Assessment of Dam Safety Coal Combustion Surface Impoundments Draft Report

American Electric Power
General James Gavin
Power Plant
Cheshire, Ohio

July 2, 2009

PROJECT NO. 20085.4000
DATE: JULY 2009
FIGURE 7A

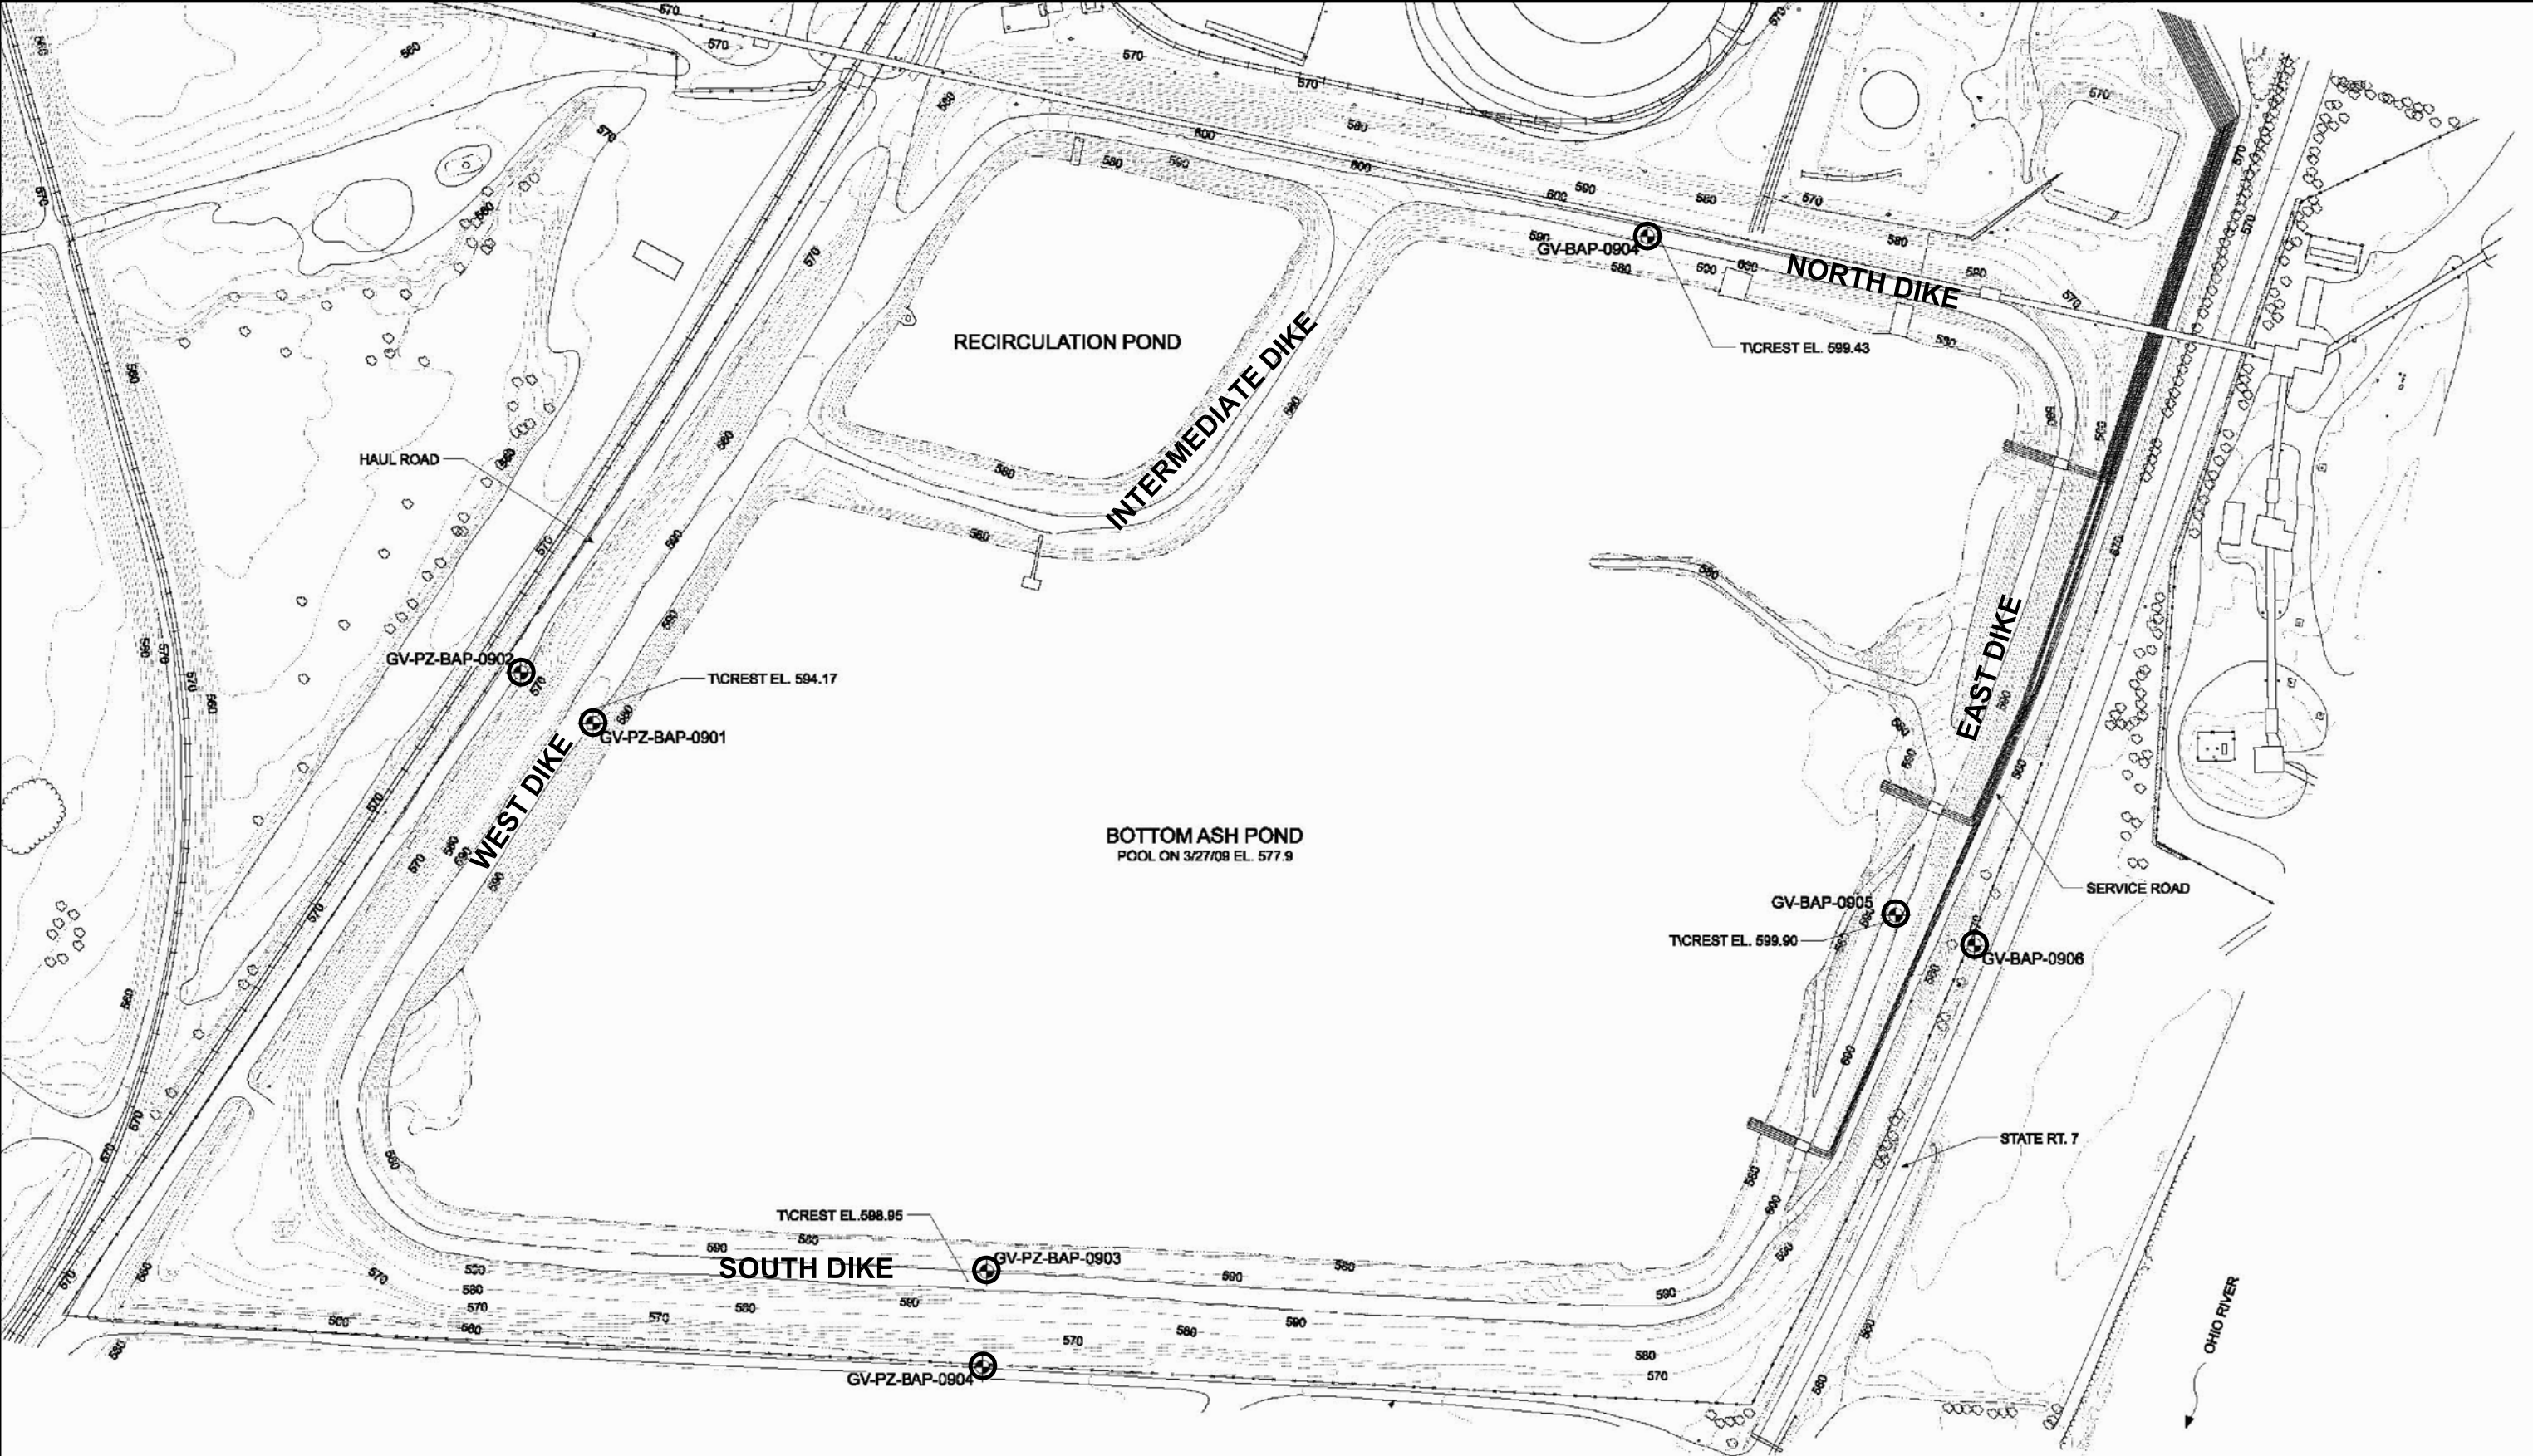
The Bottom Ash Pond is monitored with piezometers. Two “old” piezometers, BAP-1 and BAP-2, are in place at the toe of the west and south dikes, respectively. These piezometers have been monitored for many years although the installation date of these is unknown. Four additional piezometers were installed as part of a recent evaluation of the Bottom Ash Pond initiated by AEP following the TVA incident. Piezometers GV-PZ-BAP-901 through GV-PZ-BAP-904 were installed at the crest and toe of the west and south dikes as shown in Figure 7A.

Drawing Copyright © 2007 CHA	STINGY RUN DAM INSTRUMENT LOCATIONS GENERAL JAMES GAVIN POWER PLANT AMERICAN ELECTRIC POWER CHESHIRE, OHIO	PROJECT NO. 20085.4000
		DATE: JULY 2009
		FIGURE 7B

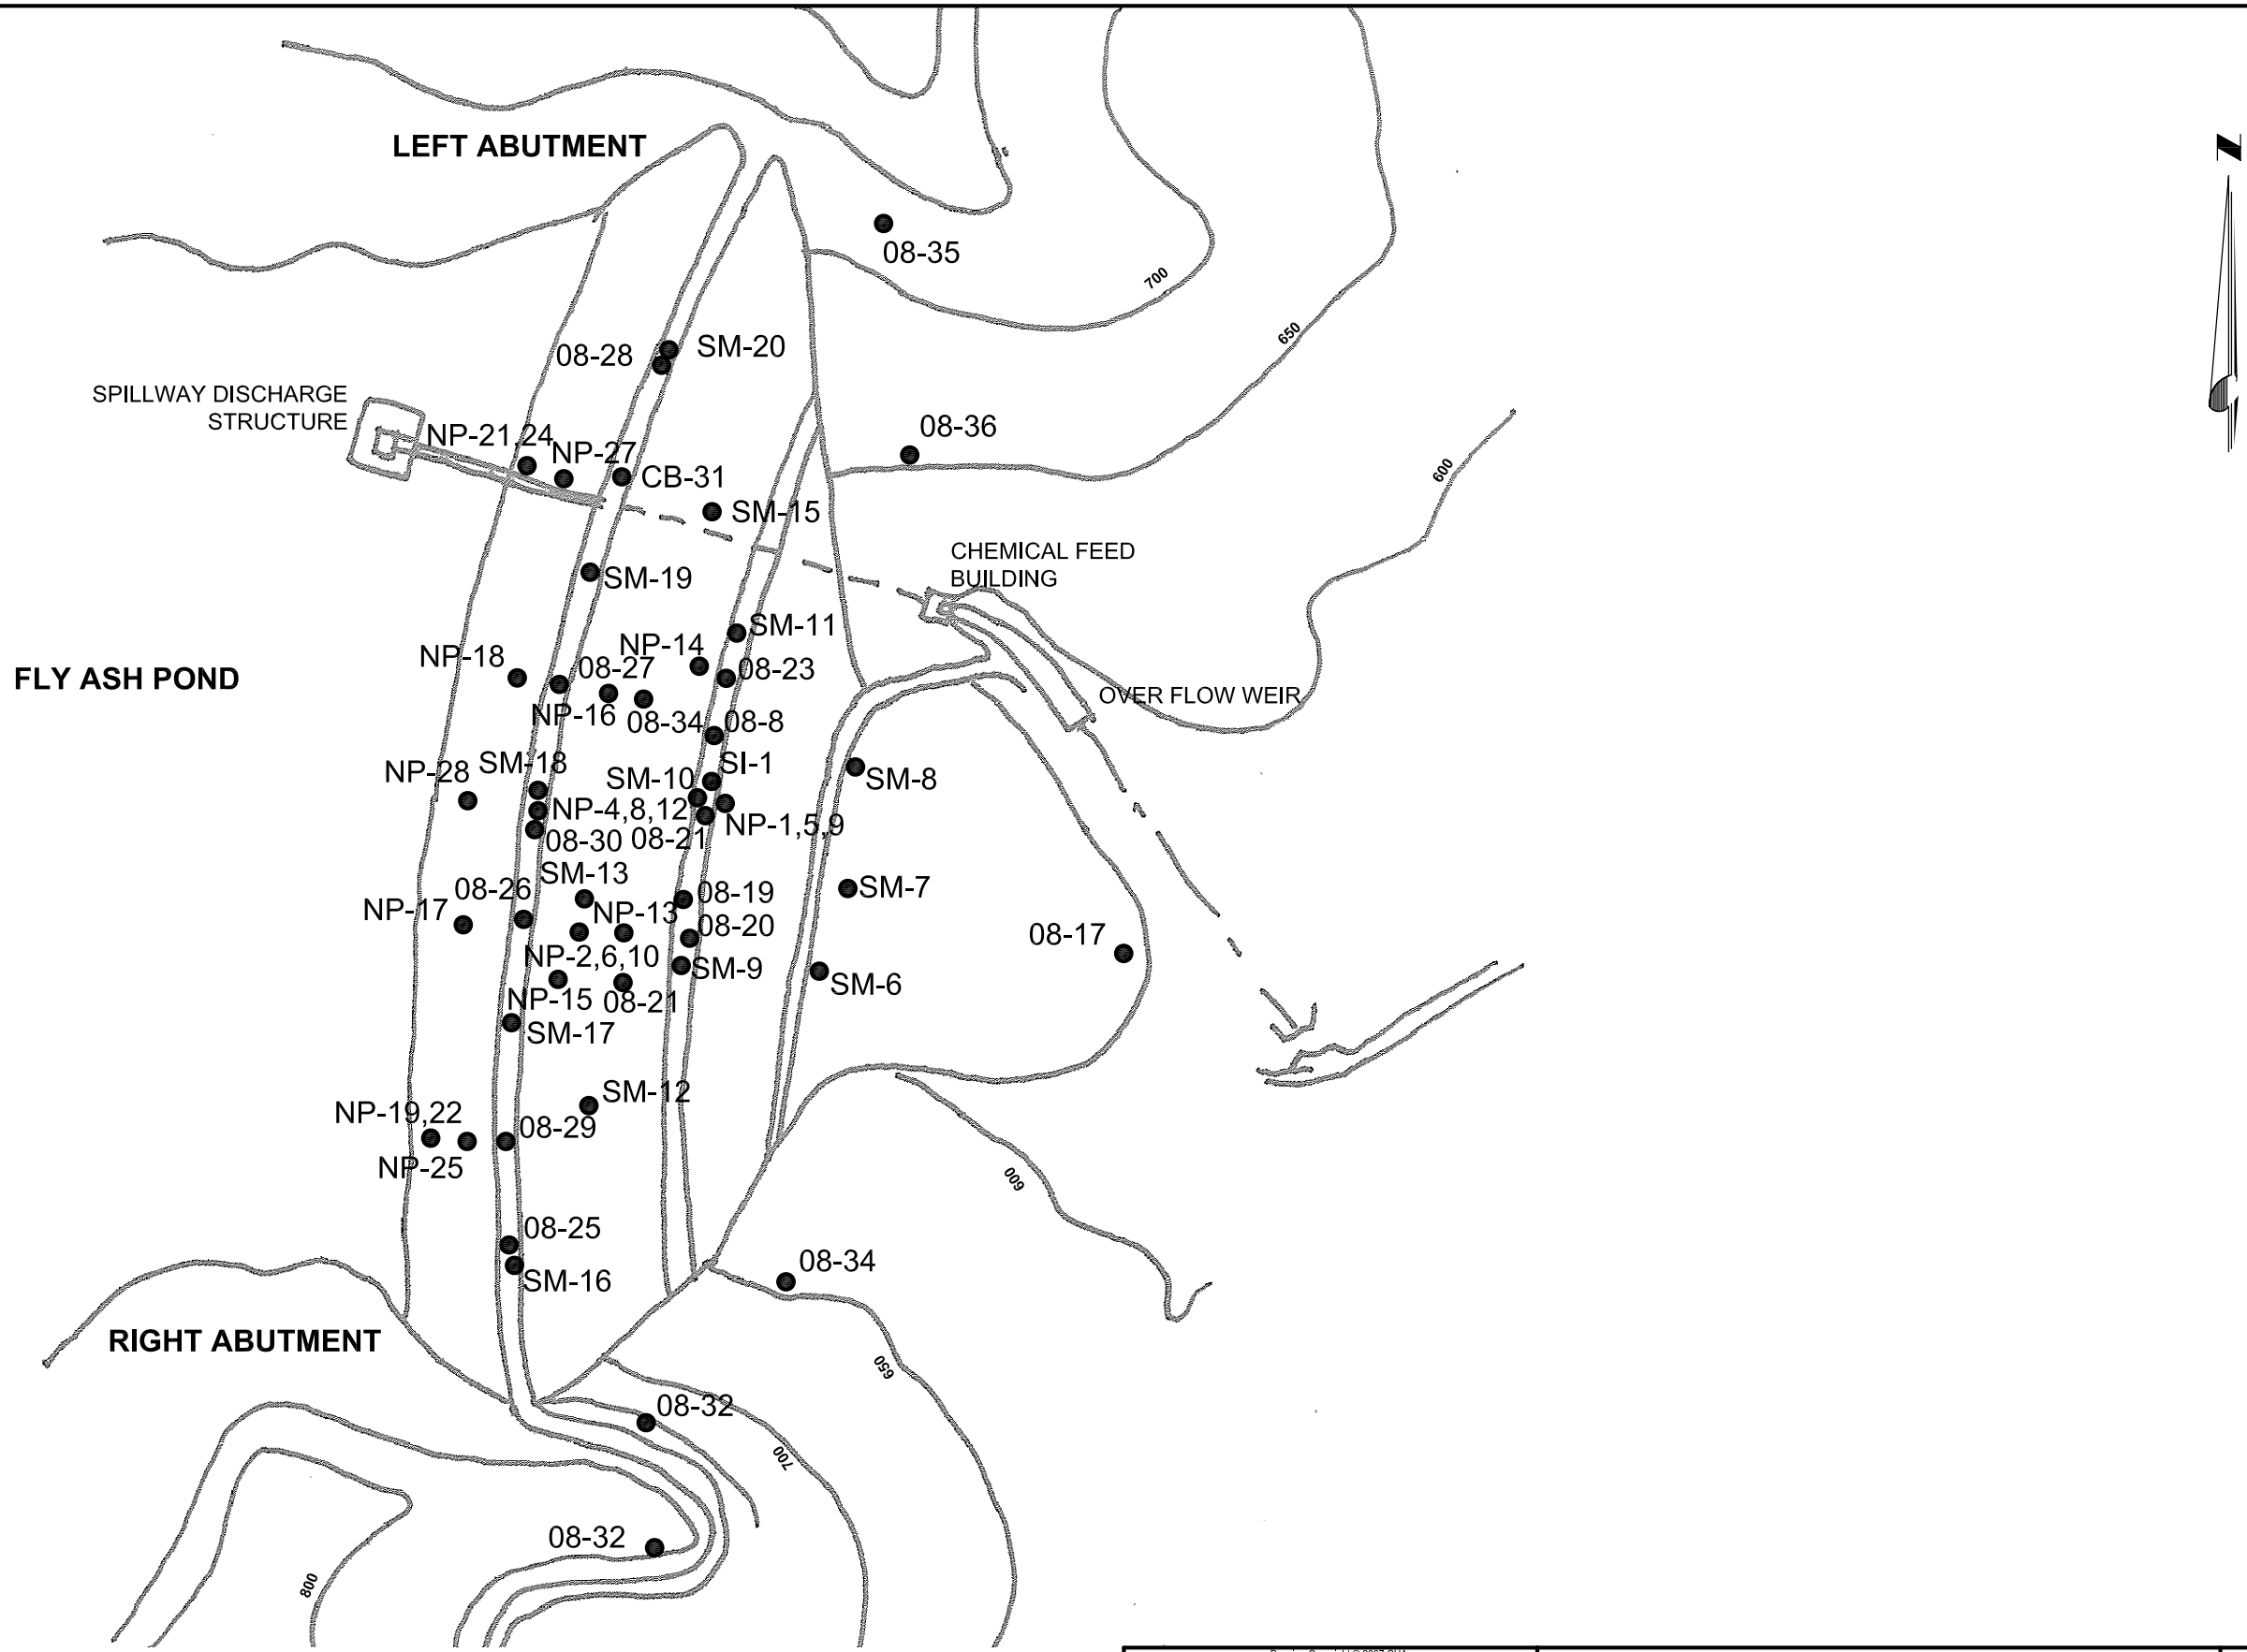
At Stingy Run Dam many piezometers, settlement monitoring monuments, and inclinometers are in place as shown in Figure 7B. The locations shown in Figure 7B represent what was provided to CHA although AEP acknowledged that some of these locations have been destroyed over the years by mowers and vandals. Therefore, this figure should not be considered an accurate depiction of currently operating instrumentation.

We recommend AEP evaluate the need for and/or replace instrumentation that has been destroyed at the Stingy Run Dam. We understand that mower damage and vandals have been a problem at this site. Additional protection may be needed at the instrument locations to protect against this damage.

FIGURE 9A

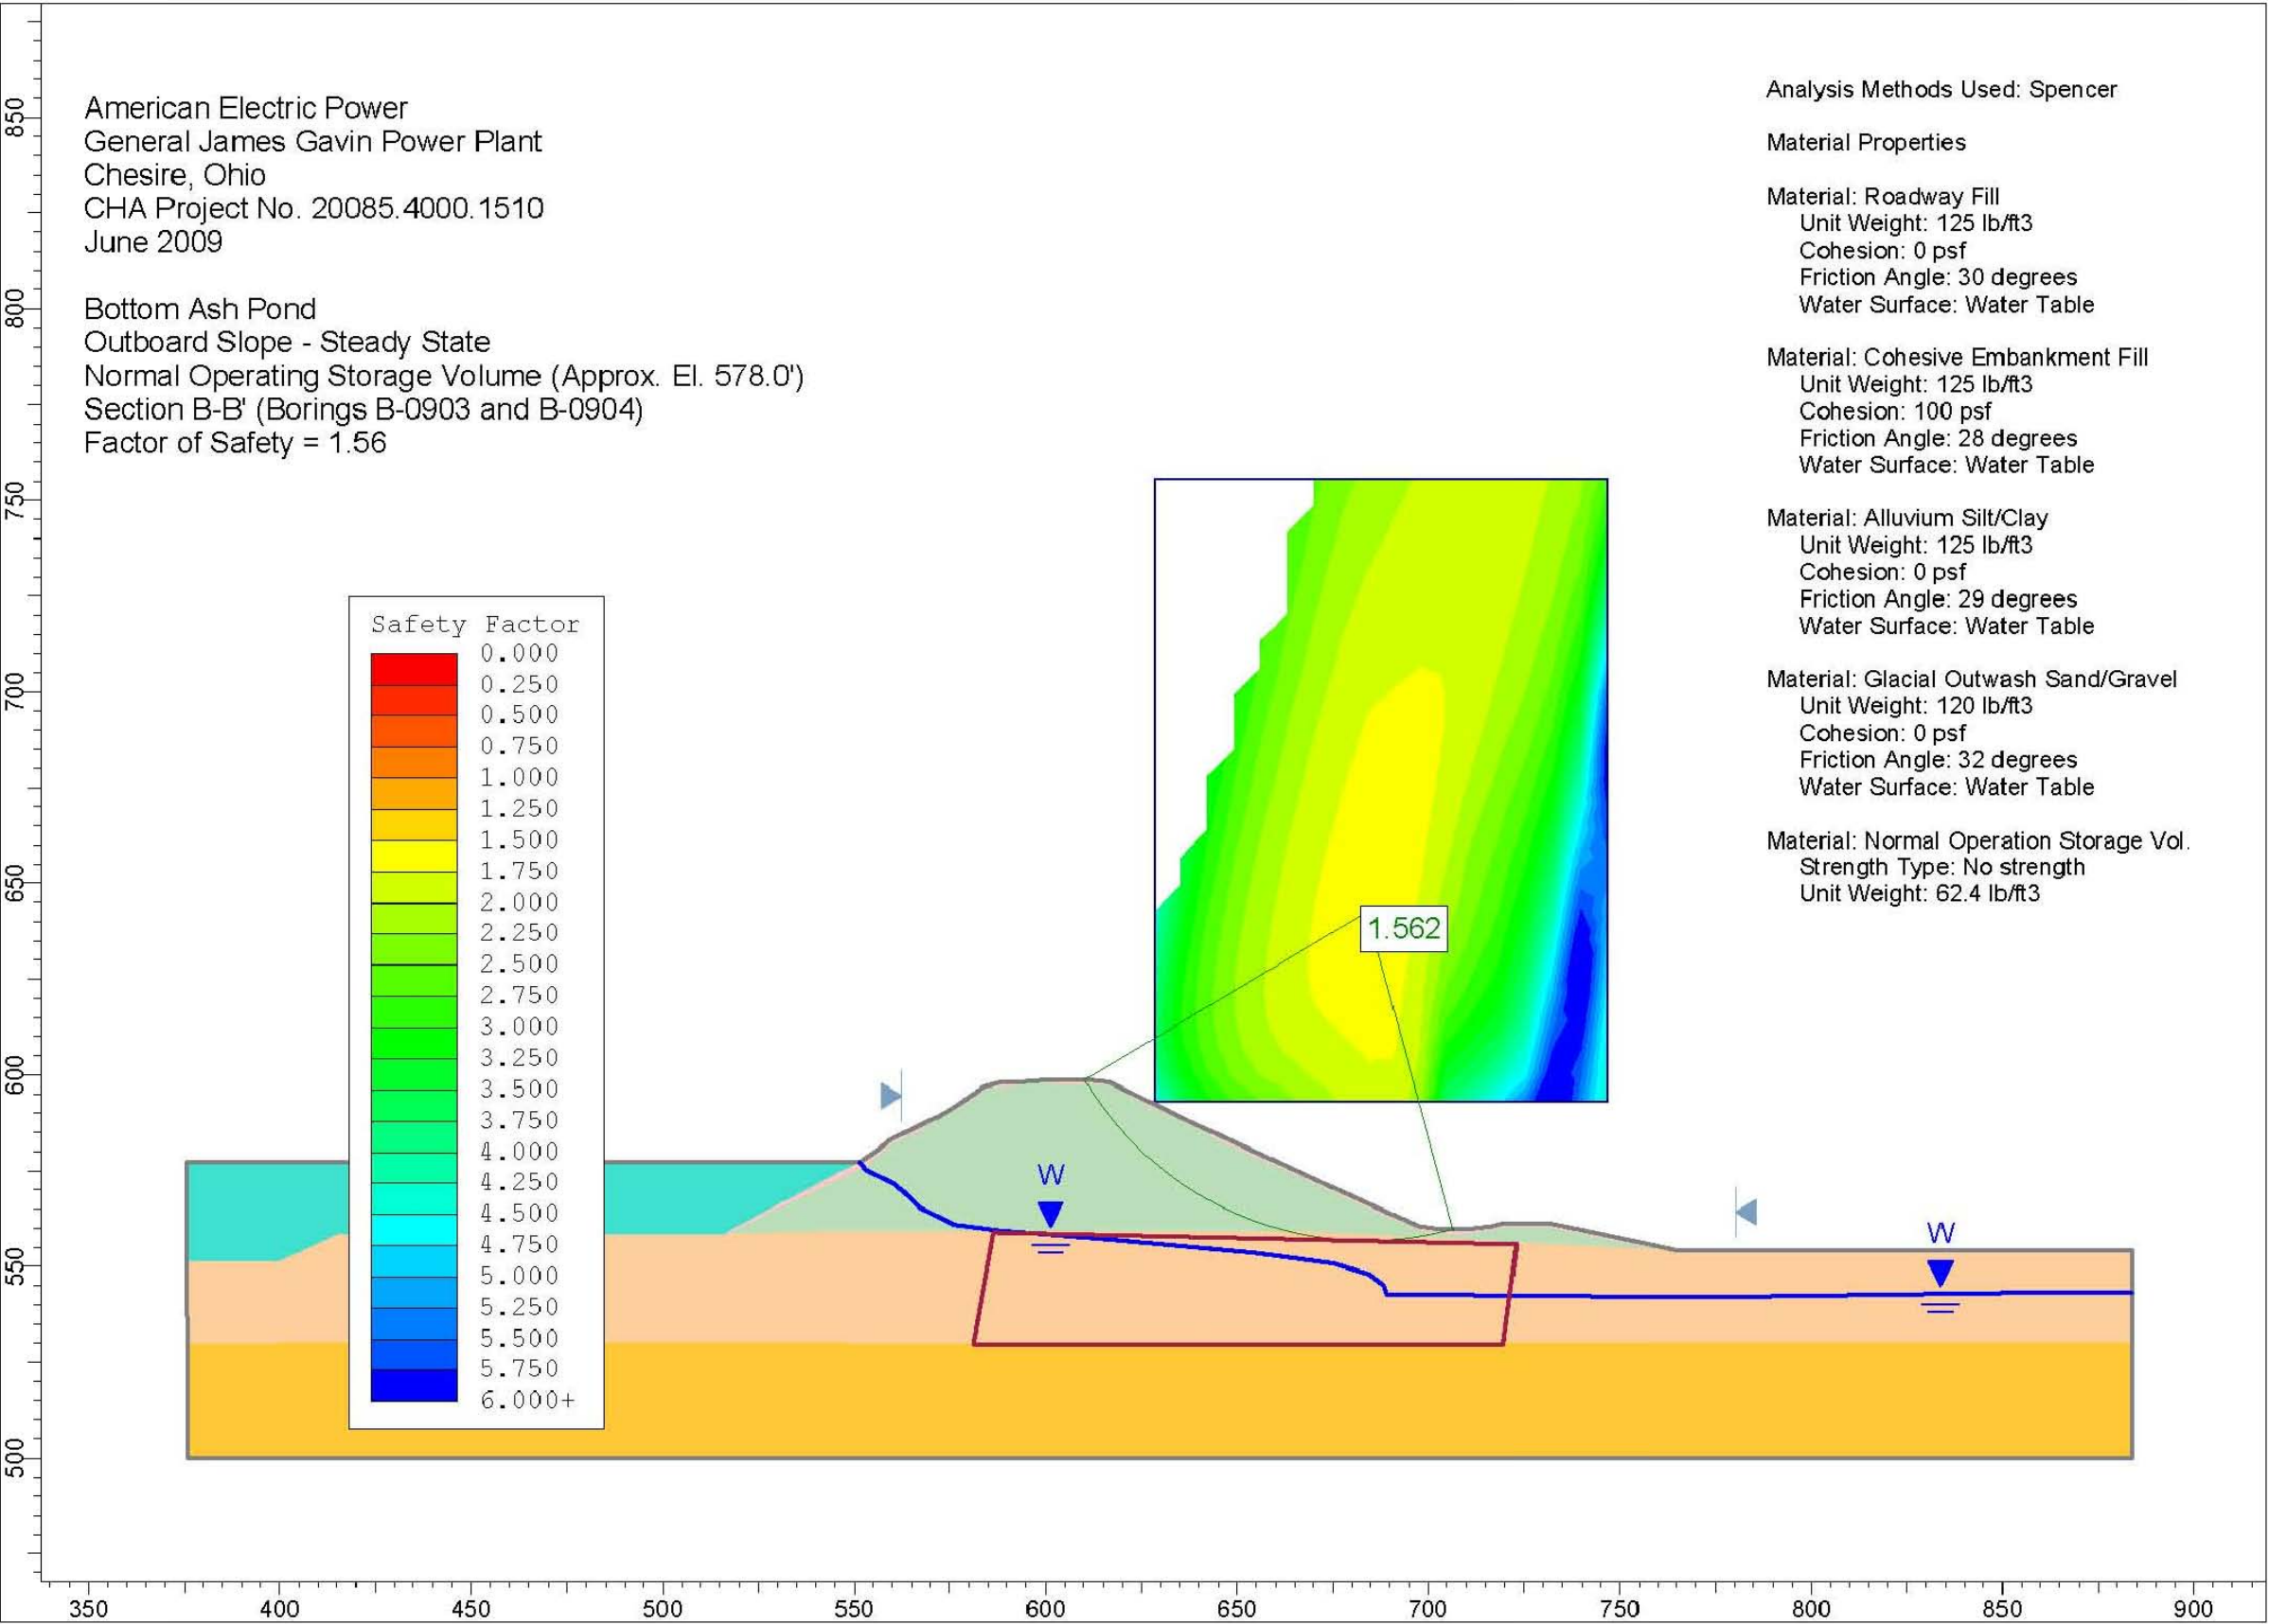
the factor of safety for this load case provided in the report. Our Slide™ output resulted in a similar factor of safety as shown on Figure 9A.
